Ford 5.4L / 6.8L Mount Kit Safety Recall

Trans/Air has become aware of isolated instances where, during the installation process, the alternator harness has become pinched between the mount plate and the heater hose spring clamp tangs at the front of the manifold. This condition could cause the harness wires to be cut, which could cause a short circuit and ignition point. Trans/Air Manufacturing is issuing a Safety Recall thru Service Bulletin #13-002, to address this concern.

View from front of engine with the tangs improperly located to the front of the engine (without mount, compressor, or alternator)

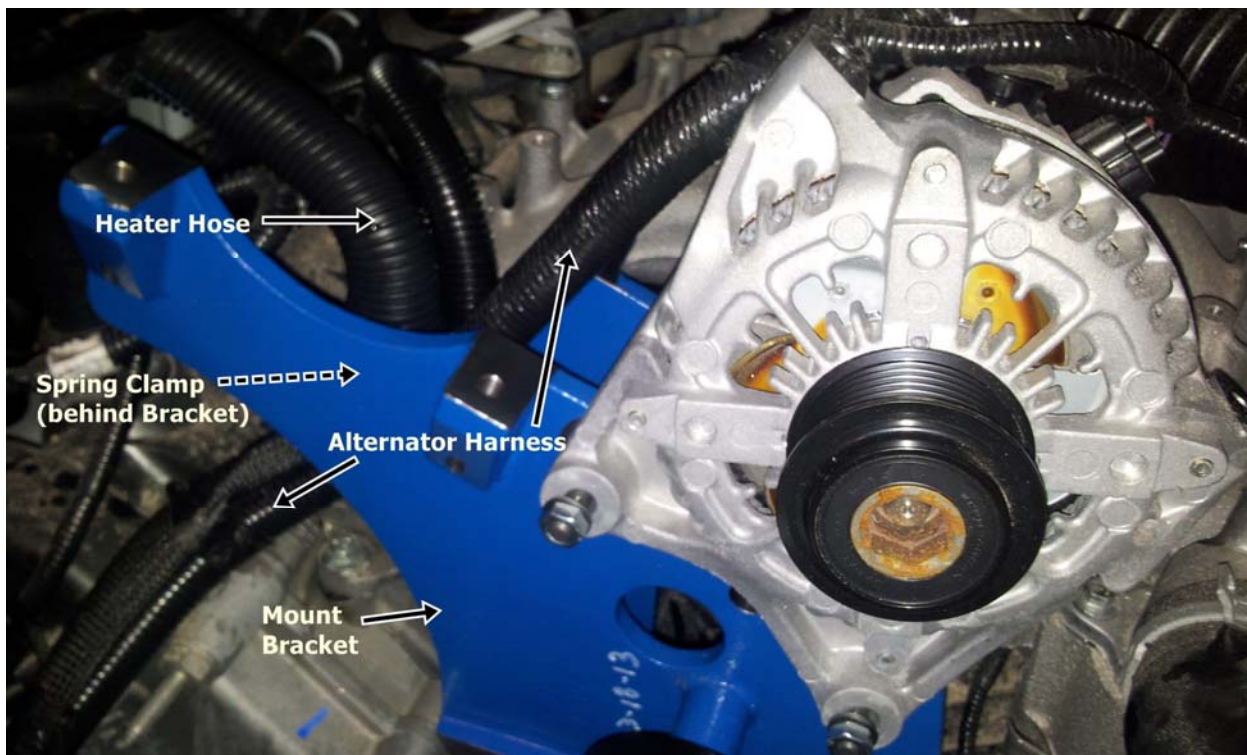
If the tab from the heater hose spring clamp is not oriented properly, (toward the rear of the engine) it could possibly pinch the alternator cable against the compressor mount plate.

Inspect the alternator harness to be sure it is not pinched between the spring clamp and the compressor mount plate, while at the same time verifying the tabs on the clamp are oriented toward the rear of the engine.

If the harness is pinched, move harness to a location that is clear of spring clamp and rotate the tangs of the clamp to the rear of the engine (See pictures below)

1. Reach behind the compressor and move the alternator cable up and down
2. If it moves without binding and you have verified that spring clamp tangs are oriented properly, to the rear of the engine, the vehicle is OK.

3. If the harness does not move, feel to see which way the spring clamp tangs are oriented. If the tangs are oriented properly, vehicle is OK.
4. Submit warranty claim to Trans/Air Mfg. for this inspection using MK-10-A flat rate code.

5. If the harness does not move, and if the tangs are not oriented properly, follow instructions below:
 - a) Remove compressor belt
 - b) Loosen the compressor from the mount bracket

- c) Lay the compressor to the left side of the bracket
 - d) Loosen the mount bracket enough to free the harness
 - e) Rotate the spring clamp on the heater hose, until the tangs are facing the rear of the bus

- f) Inspect harness for damage and repair if necessary
 - g) Contact Trans/Air Warranty for authorization if repair is necessary
 - h) Tighten the mount bracket

- i) Re-check to make sure the harness is not binding or pinched
 - j) Mount the compressor back into the bracket
 - k) Re-install belt
 - l) Submit warranty claim to Trans/Air Mfg. for this inspection using MK-45-A flat rate code
